PCB PART 1001723.PCB

File	OASIS3 BACKPLANE BOARD	Rev	A
Size	Document Number		
D	1001718.SCH		
Date	Monday, January 27, 2003	Sheet	0 of 1

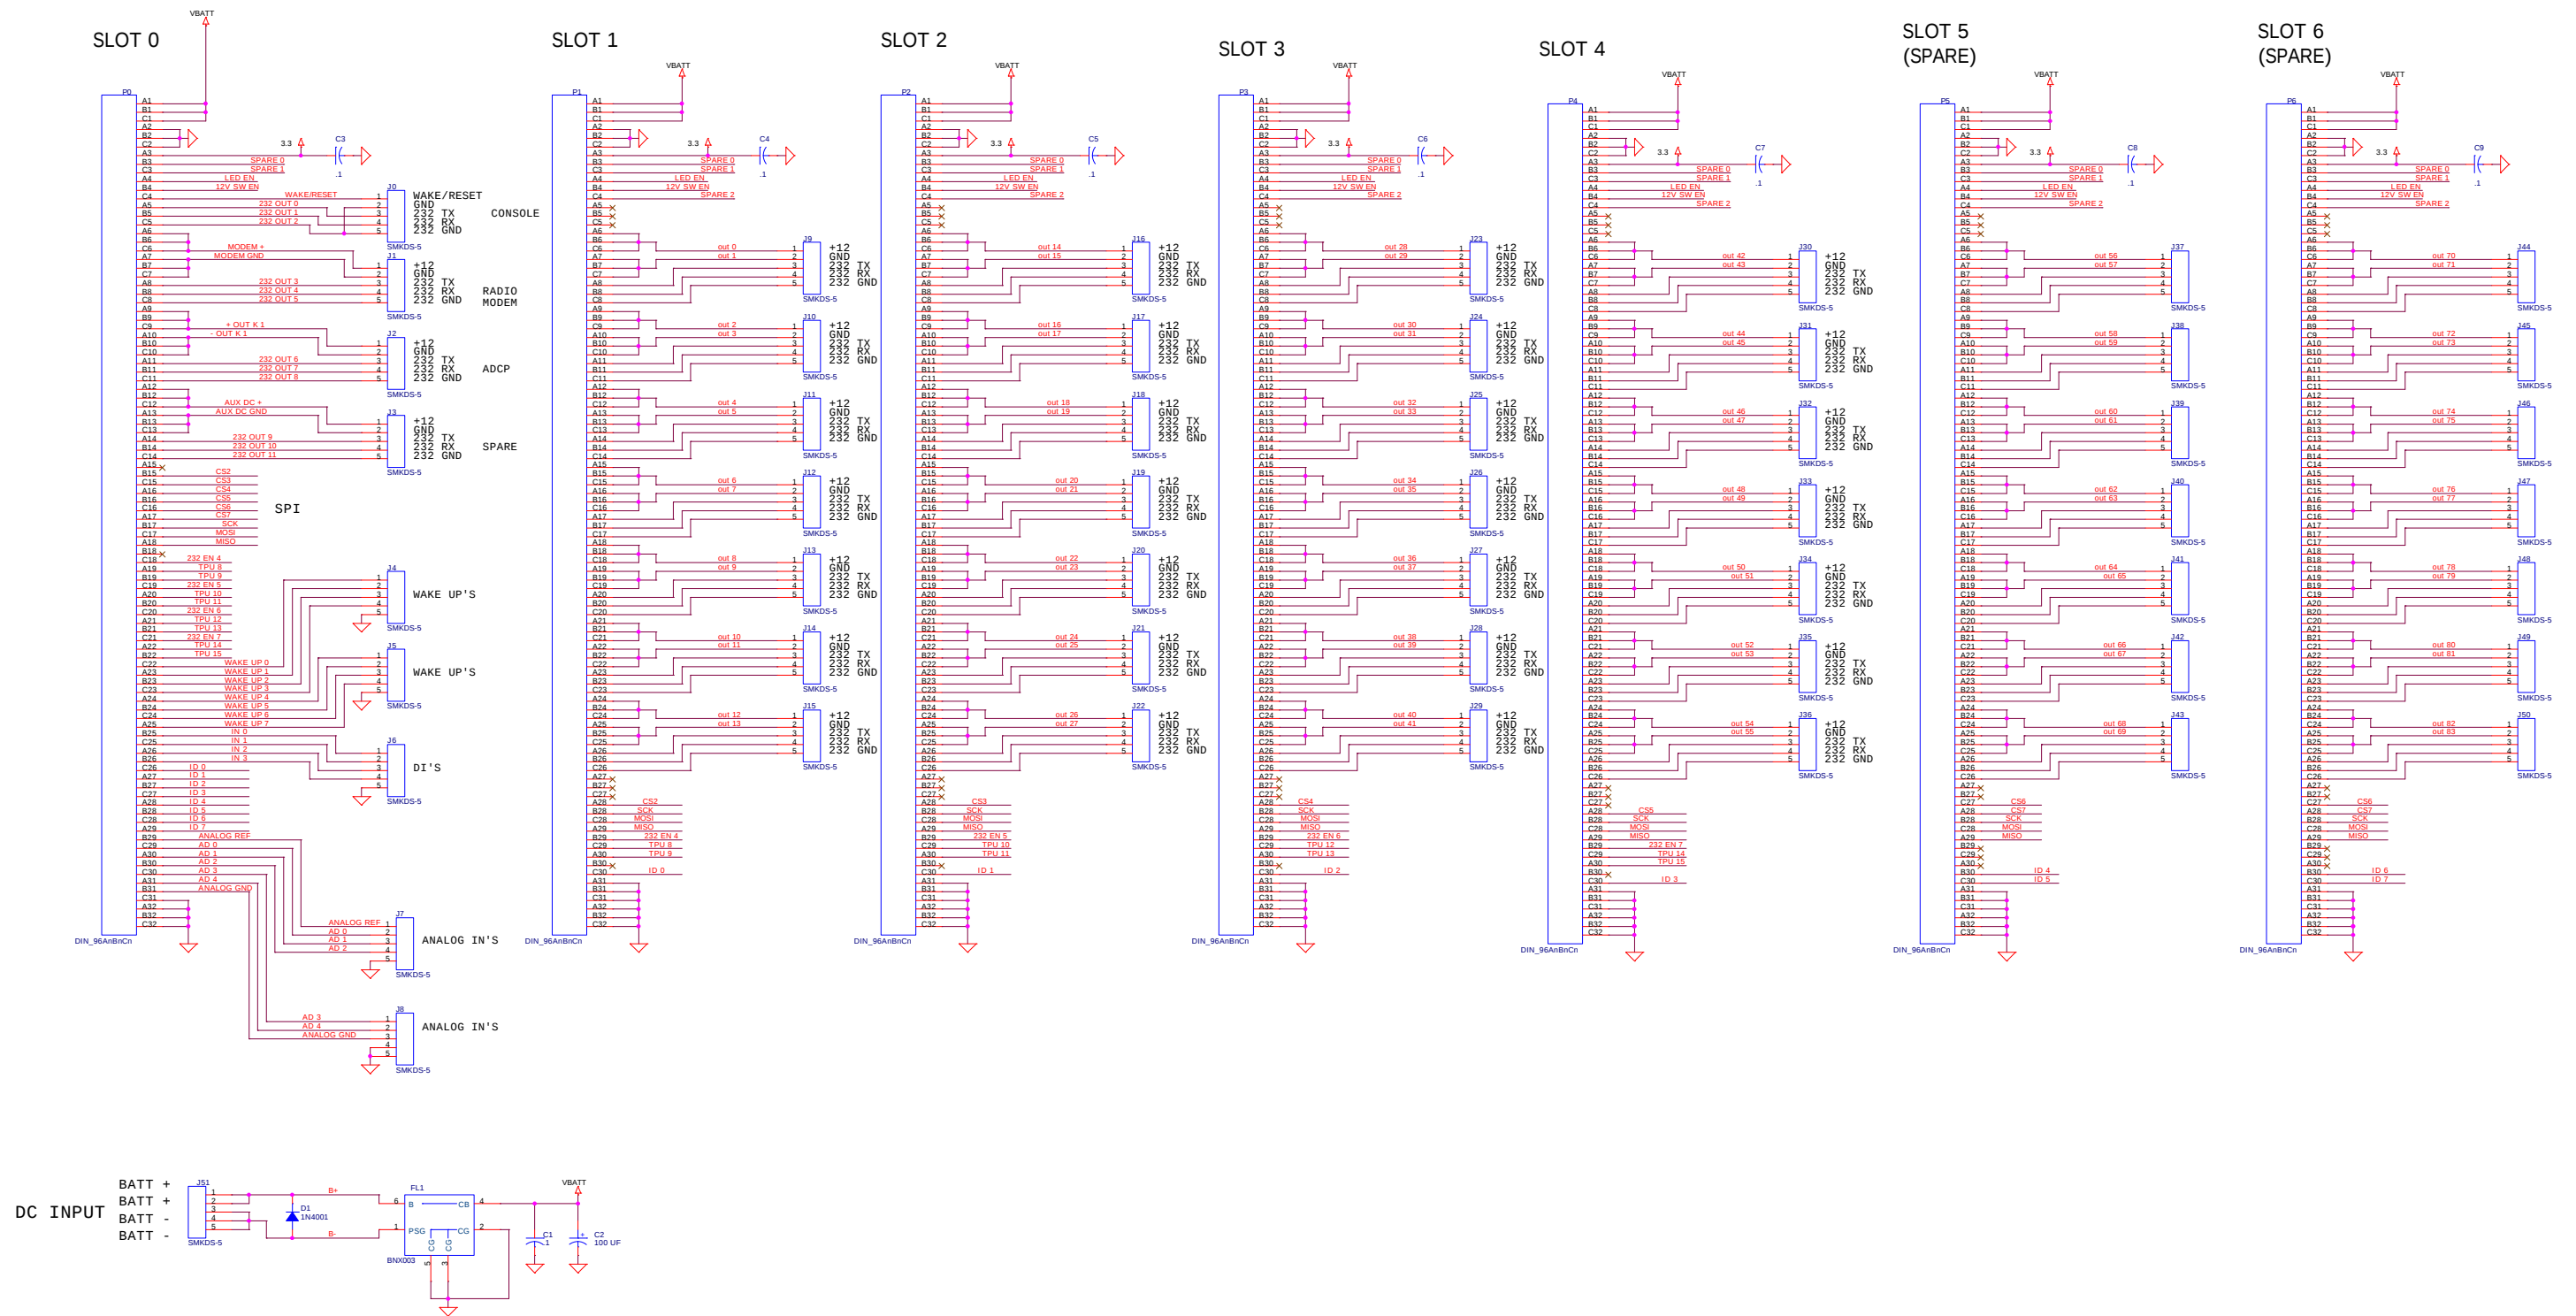
REV A ADD .1 BYPASS CAPS, CHANGE TO POL CAP C2
CHANGE SMKDS FOOTPRINT HOLE SIZE TO .652
CORRECTED SLOT 6 SPI BUSS CONNECTION LOCATION
